WEST HAVEN CITY
PLANNING COMMISSION AGENDA

November 13, 2024
City Council Chambers
4150 South 3900 West, West Haven, UT 84401

Planning Commission
Staff Review Memo

FINAL SITE PLAN APPROVAL

POND CROSS SECTION (A)
SCALE: NTS

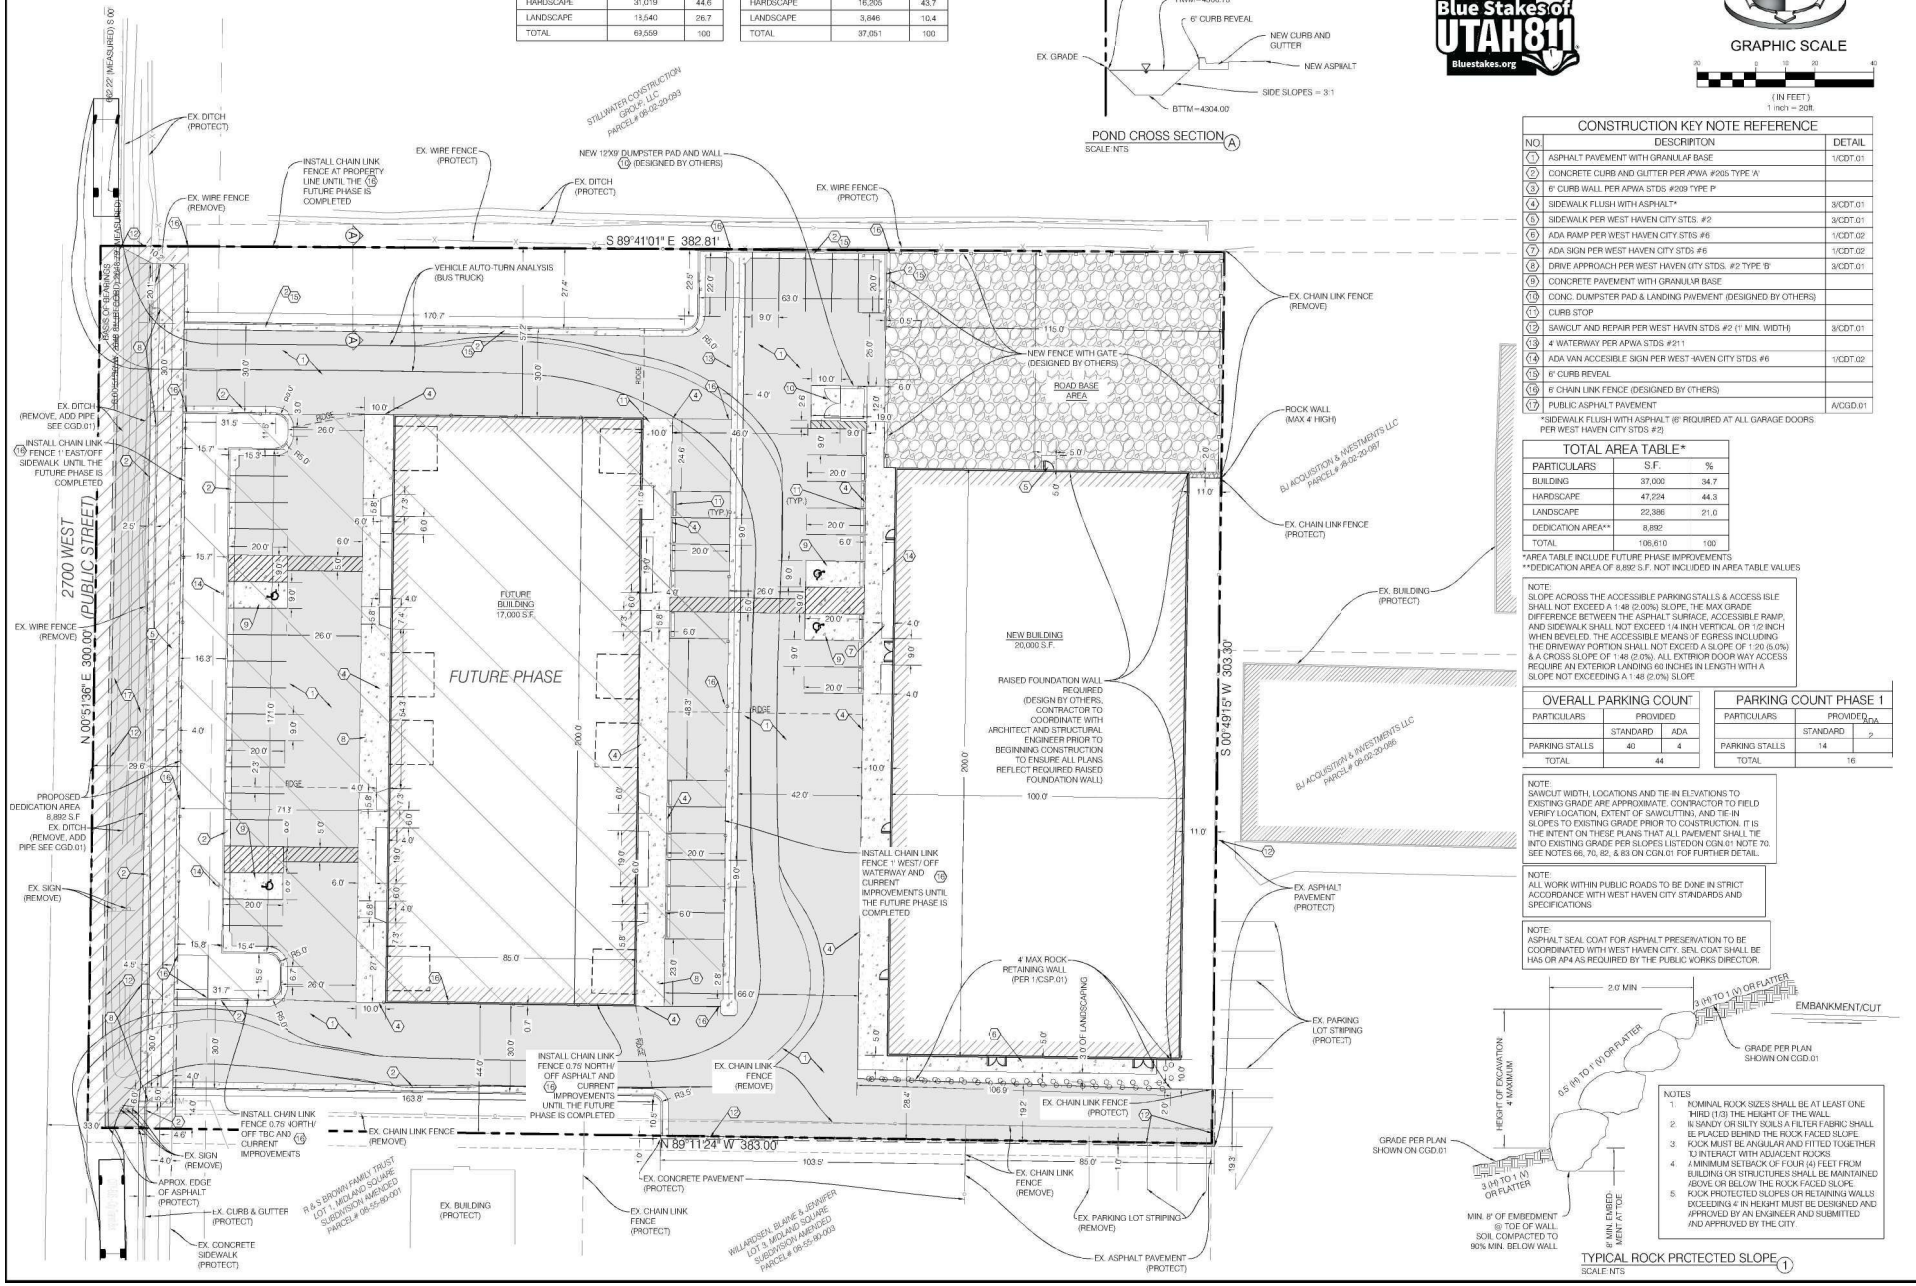
4) Ponds shall include 1 ft freeboard.
   The pond was changed to include 1 ft of freeboard.
5) Stormwater appears to runoff onto the site to the south. This must be mitigated. Refer to redlined PDF, Sheet 5 of 11.
   Slopes and elevations provided to show that the water does not run off the site.

2700 WEST PLAN

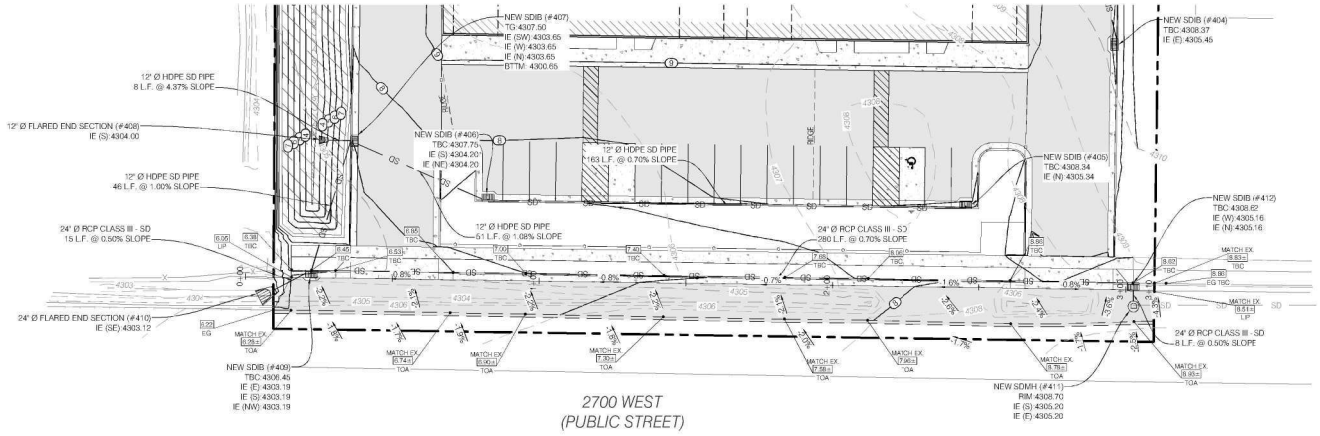
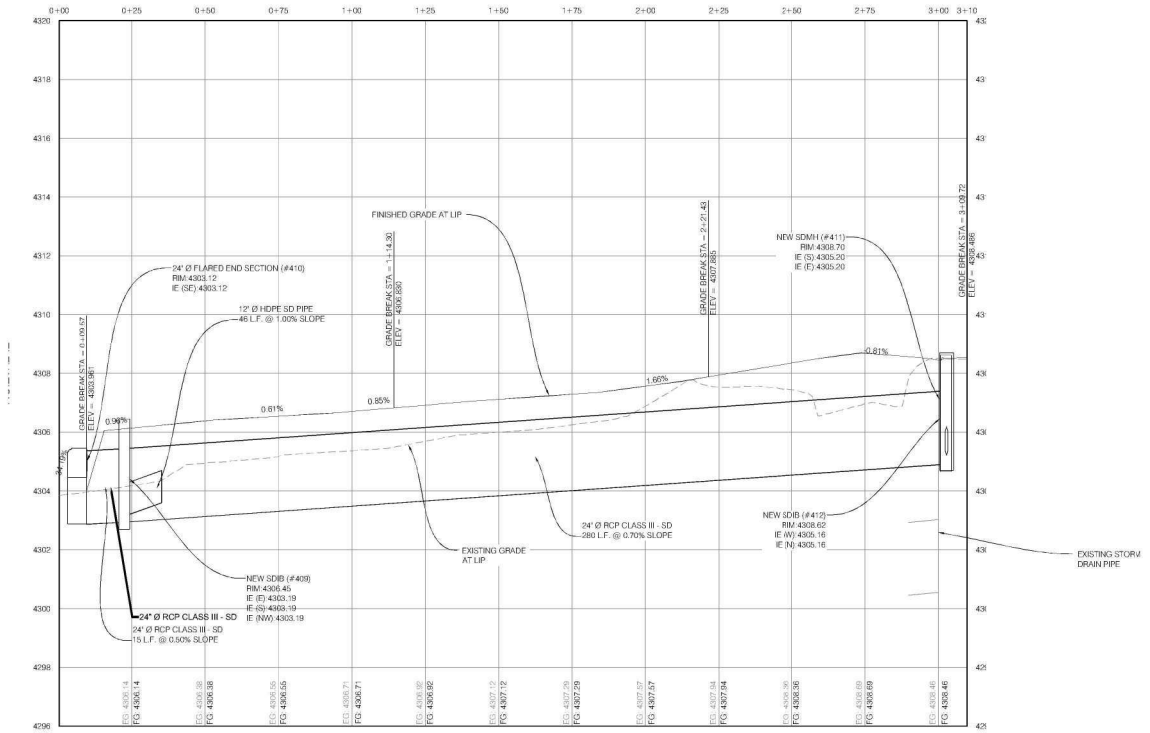
3) Provide a roadway widening section detail for 2700 West.
   - Minimum city requirements:
     a. 4" asphalt
     b. Match existing asphalt depth
     c. Verify depth with Public Works Director
     d. 8" base course
     e. 12" subbase/granular borrow
